# Access Compliance Report

## Public Rights-of-Way

### (Curb Ramps)

Intersection ID: 21772	Main Street: DOVERSHIRE_RD	Cross Street: SARDIS_RD	Location:	NE
ADA ID: 33FF7B6305DC	Ramp Type: BlendTrans2	Initial Pass/Fail: Fail	Overall Compliance: No	Severity Score: 10
Codes/Mitigation Info/Possible Solution		Field Measurements/Component Compliance

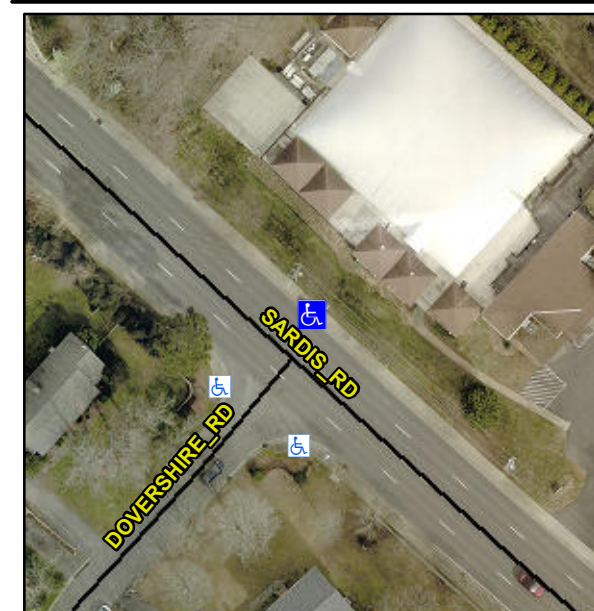
**Not Found, R304.5.1, R304.5.3**

Compliance	Description	Data	Compliance	Description	Data
N/A	Ramp Length (in)	60.0	Yes	BlendTrans Slope (%)	2.8
No	Ramp Width (in)	45.5	No	BlendTrans XSlope (%)	3.1
N/A	Flare Type LT	N/A	N/A	Flare Type RT	N/A
N/A	Flare Slope LT (%)	N/A	N/A	Flare Slope RT (%)	N/A
N/A	Flare Traversable LT?	N/A	N/A	Flare Traversable RT?	N/A
N/A	Landing Length (in)	N/A	N/A	DWS Provided?	N/A
N/A	Landing Width (in)	N/A	N/A	DWS Contrast?	N/A
N/A	Landing Slope (%)	N/A	N/A	DWS Length (in)	N/A
N/A	Landing X Slope (%)	N/A	N/A	DWS Full Width?	N/A
N/A	Landing Curb? (Y/N)	N/A	N/A	DWS Offset (in)	N/A
N/A	Shared Landing?	N/A			
N/A	Gutter Ponding?	N/A	N/A	Gutter Slope (%)	N/A
N/A	Gutter Lip Ht (in)	N/A	N/A	Gutter X Slope (%)	N/A
N/A	Painted X Walk1?	No	N/A	Painted X Walk2?	N/A
	X Walk 1 Direction	To SW		X Walk 2 Direction	N/A
	X Walk 1 Width (in)	N/A		X Walk 2 Width (in)	N/A
	X Walk 1 Slope (%)	0.8		X Walk 2 Slope (%)	N/A
	X Walk 1 X Slope (%)	1.9		X Walk 2 X Slope (%)	N/A

N/A	Ramp inside XWalk1?	N/A	N/A	Ramp inside XWalk2?	N/A
	Road Slope (%)	1.9		Clear Space?	N/A
	Road X Slope (%)	0.8	N/A	Clear Space to XWalk (in)	N/A
N/A	Any Obstructions?	N/A	N/A	Storm Grate/Utility Hazard?	N/A
	Obstruction Type			Storm Grate/Utility Type	
		N/A			N/A
			Yes	Surface Condition? (G/P)	Good
			No	Curb Slope (%)	12.5

**Remove & Replace Curb Ramp With Two New Directional Ramps or Equivalent.**
